# The Calcutta Gazette

## APPENDIX.

### Notices to Mariners.

THE following Notices are republished for general information.

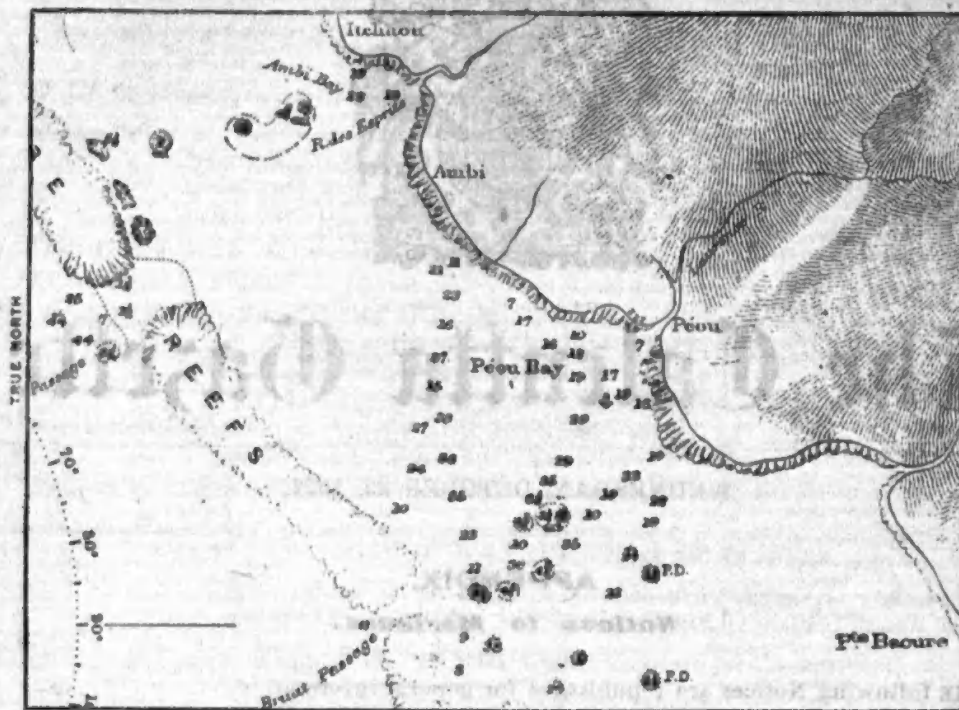
*Details.*—The accompanying reproductions of portions of charts Nos. 986 and 17 show the necessary amendments to the charts with regard to coastline, reefs, shoals and depths in the vicinity of Péou and Ambi bays.

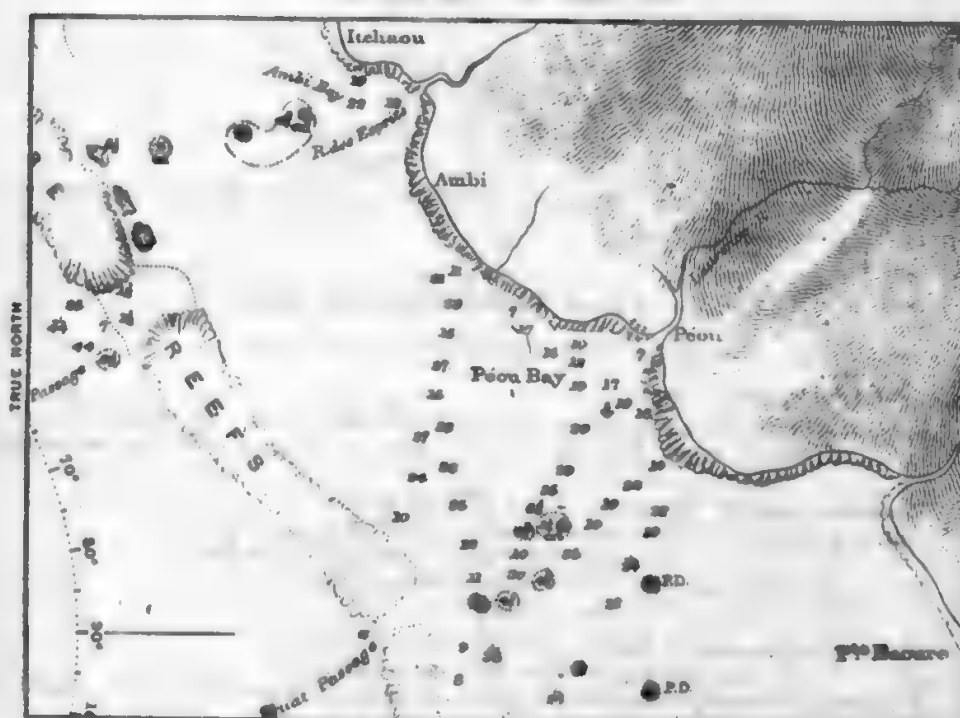
*Details.*—The accompanying reproductions of portions of charts Nos. 986 and 17 show the necessary amendments to the charts with regard to coastline, reefs, shoals and depths in the vicinity of P éou and Ambi bays.

Reproduction of Portion of Chart No. 1970.

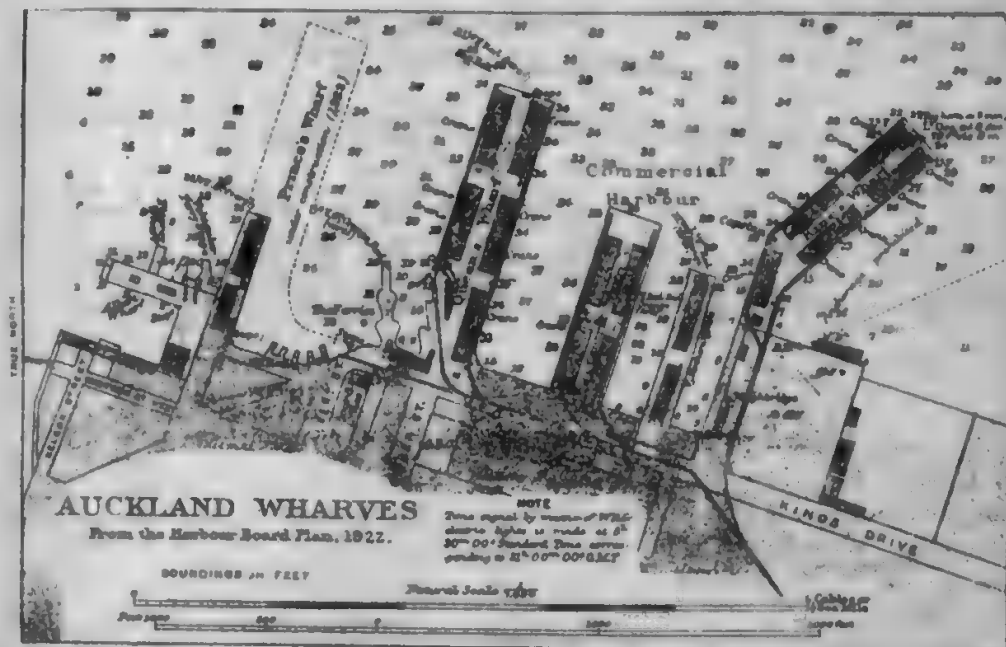
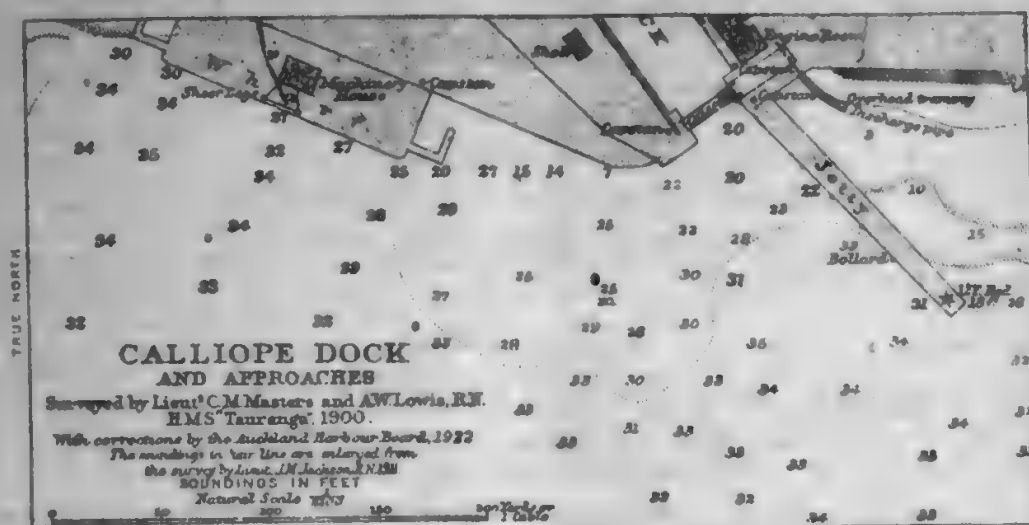
*Details.*—The accompanying reproductions of portions of charts Nos. 1970 and 1896 show necessary amendments to the charts with regard to wharves and depths at Auckland, also amended depths in the approaches to Calliope dock at Devonport.

*Note.*—From the reproductions it will be seen that a *flood white light* now marks the new Western wharf at Auckland.

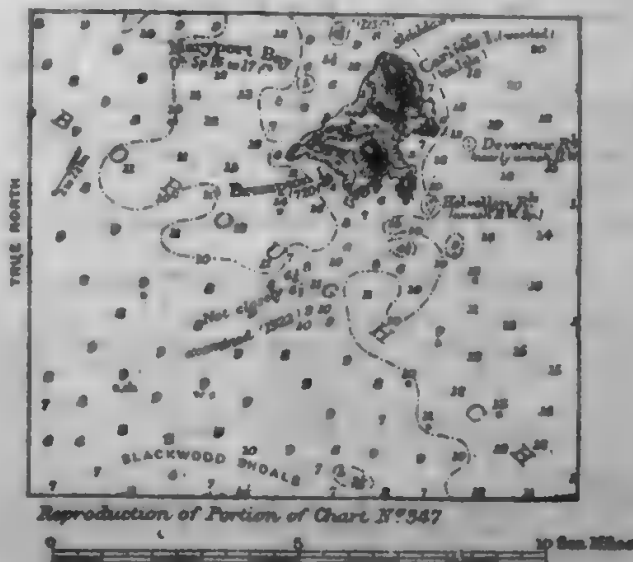
*Details.*—The accompanying reproduction of a portion of chart No. 347 shows the necessary amendments to the chart with regard to decreased depths south-westward of Brampton island.

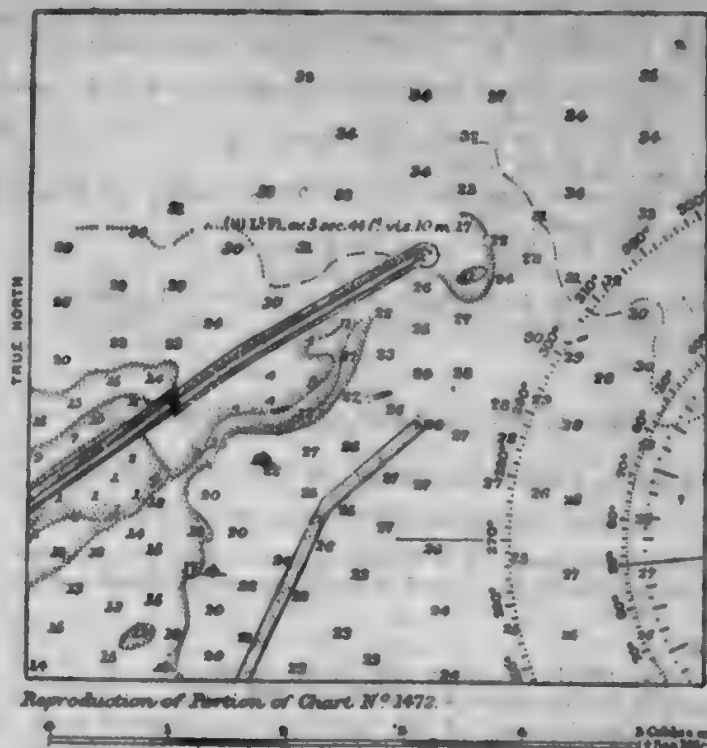
*Details.*—Amendments to the undermentioned plan on chart No. 1472 with regard to the moles, depths and mooring buoys at the entrance to Koombanah harbour, embodying the latest information received, are shown on the accompanying reproduction of a portion of that plan.

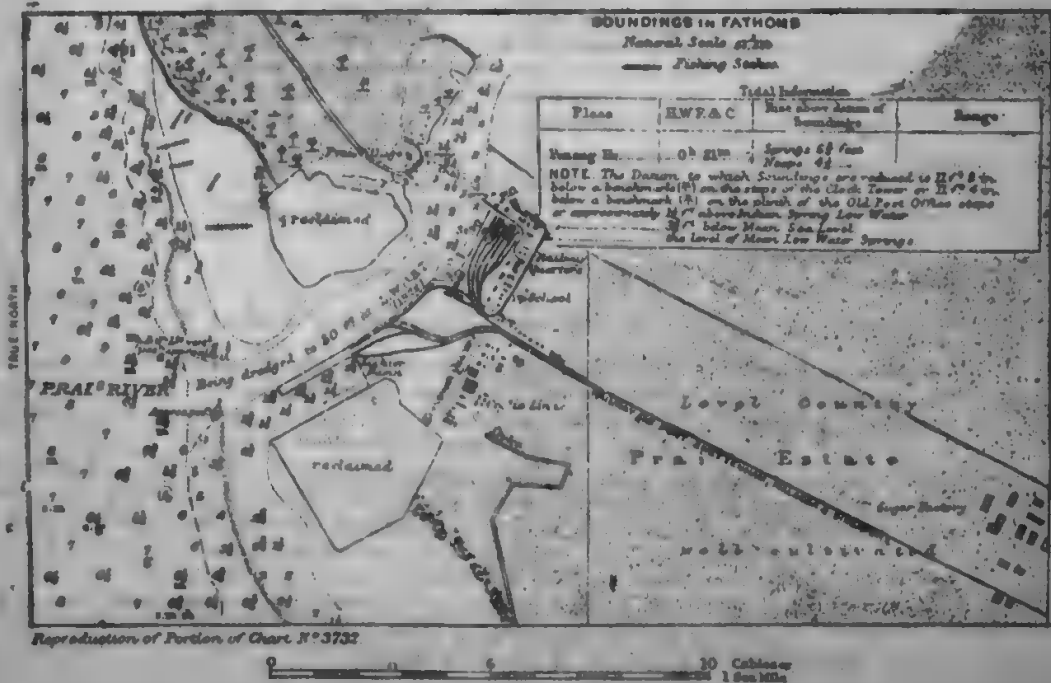
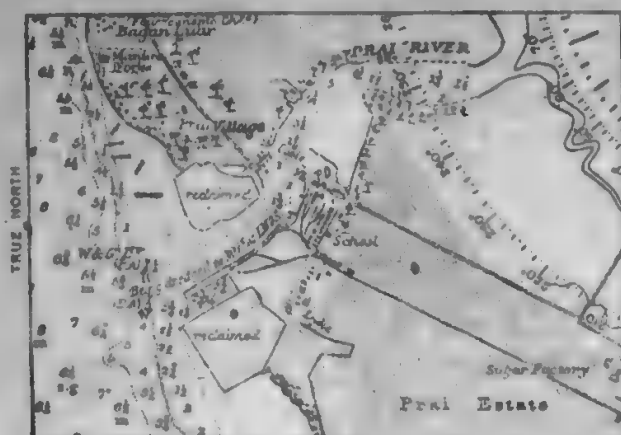
*Details.*—General amendments to the charts in regard to Prye river entrance, embodying the latest information received, are shown on the accompanying reproductions of portions of charts Nos. 3732 and 1366.

Reproduction of Portion of Chart N° 1970.

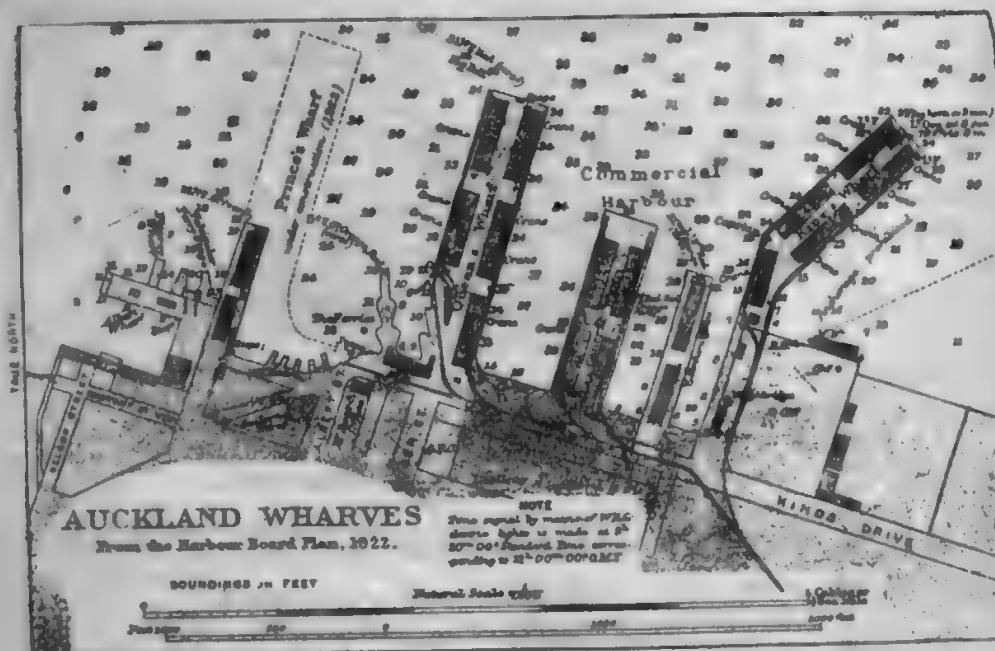
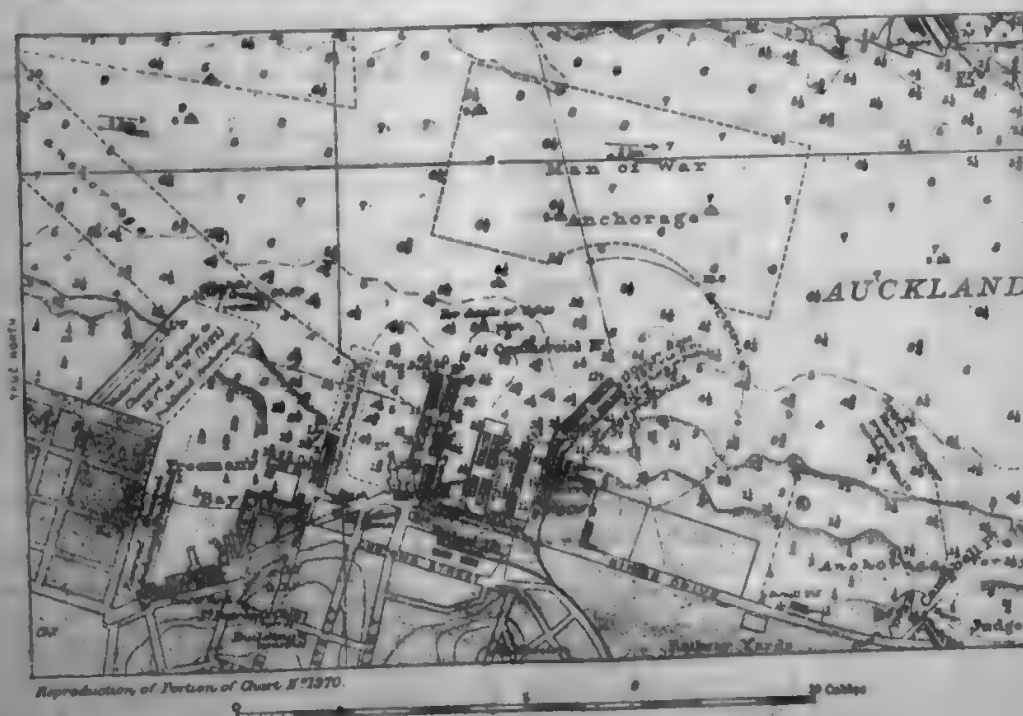
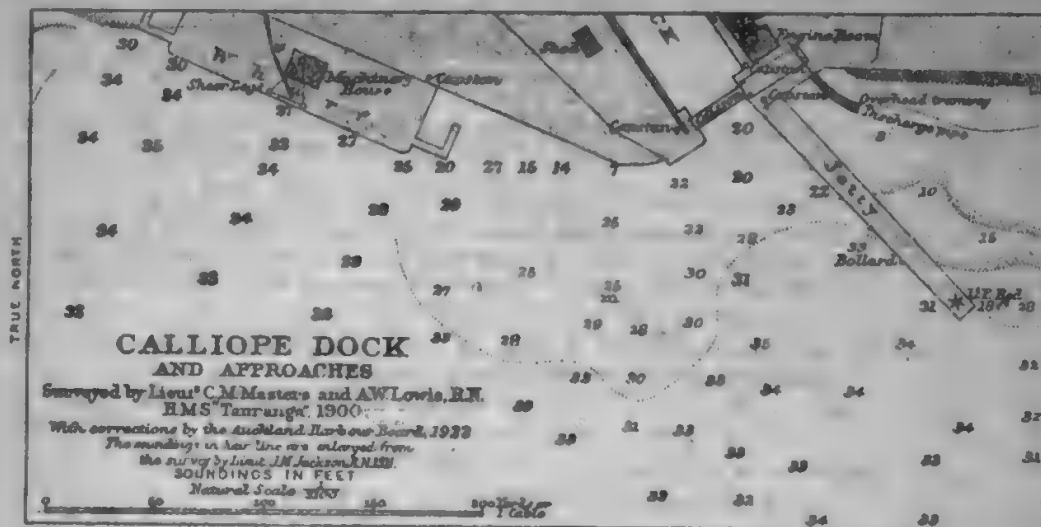
*Details.*—The accompanying reproductions of portions of charts Nos. 1970 and 1896 show necessary amendments to the charts with regard to wharves and depths at Auckland, also amended depths in the approaches to Calliope dock at Devonport.

*Note.*—From the reproductions it will be seen that a *fixed white* light now marks the new Western wharf at Auckland.

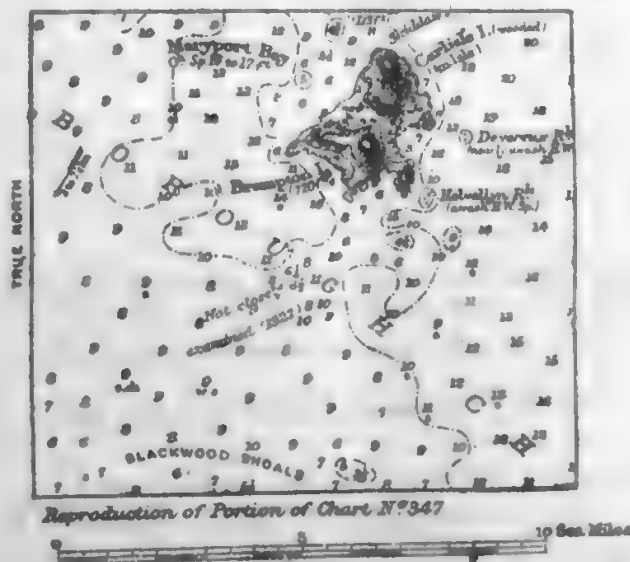
*Details.*—The accompanying reproduction of a portion of chart No. 347 shows the necessary amendments to the chart with regard to decreased depths south-westward of Brampton island.

Reproduction of Portion of Chart No. 2089.

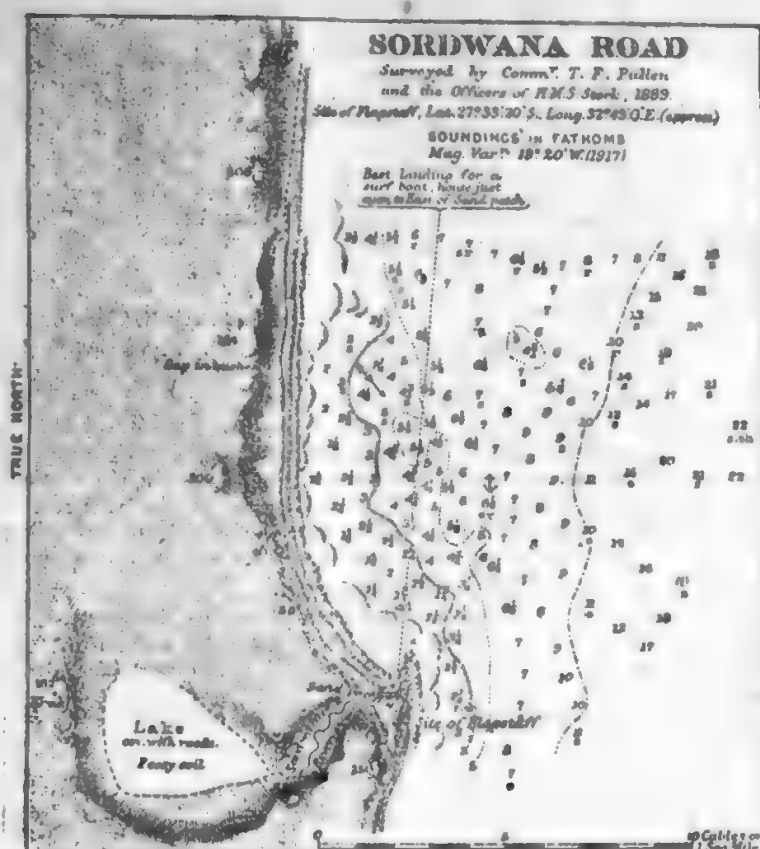
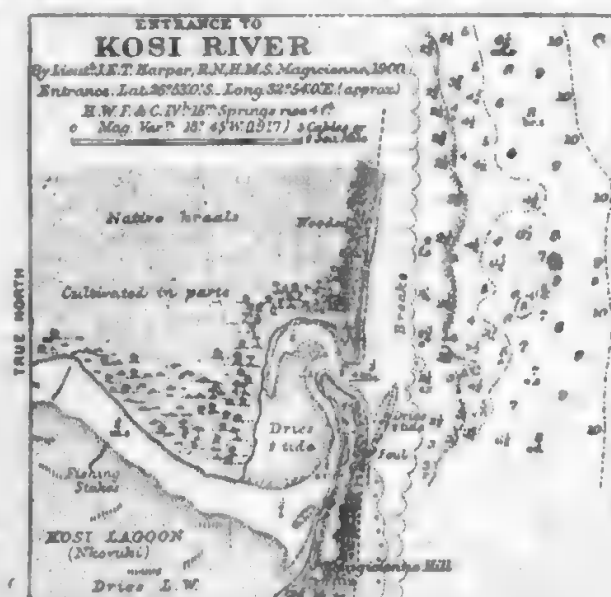
*Details.*—The accompanying reproduction of the plans of Sordwana road and entrance to Kosi river on chart No. 2089 shows the necessary amendments to the chart with regard to shoals and depths in the two localities referred to.

Reproduction of Portion of Chart No. 3642

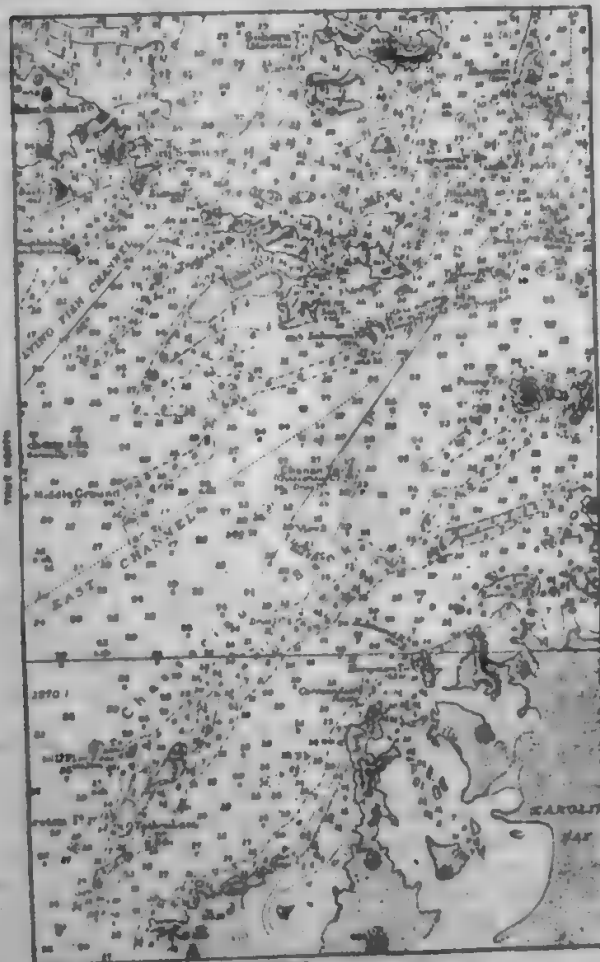
*Details*.—The accompanying reproductions of portions of charts Nos. 3642 and 1258 show the necessary amendments with regard to depths and shoals in East and Flying Fish channels and their vicinities.

*Remarks.*—The above rock and shoal, which are to be inserted on chart No. 3642, are not included in the reproduction of the portion of that chart.

Reproduction of Portion of Chart No. 1472.

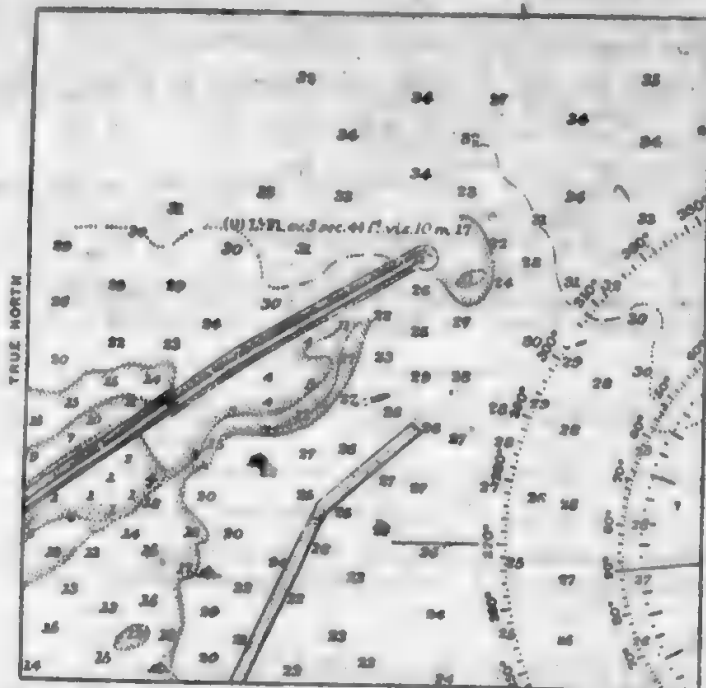
*Details.*—Amendments to the undermentioned plan on chart No. 1472, with regard to the moles, depths and mooring buoys at the entrance to Koombanah harbour, embodying the latest information received, are shown on the accompanying reproduction of a portion of that plan.

Reproduction of Portion of Chart No. 3732.

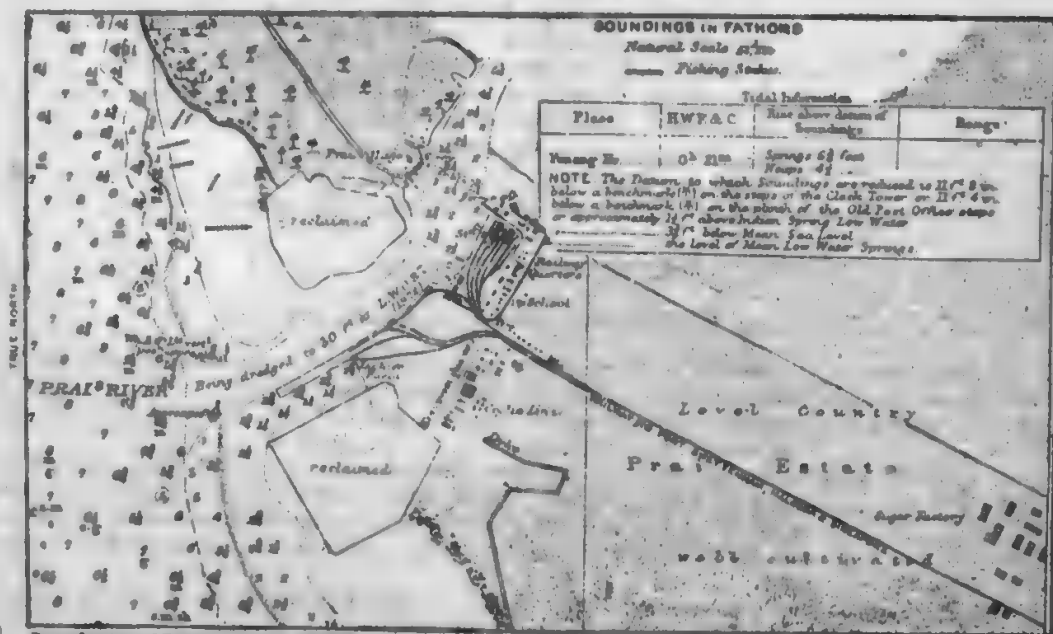
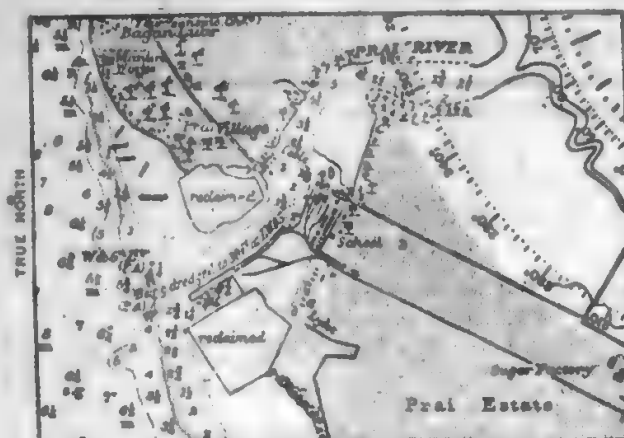
*Details.*—General amendments to the charts in regard to Prye river entrance, embodying the latest information received, are shown on the accompanying reproductions of portions of charts Nos. 3732 and 1366.
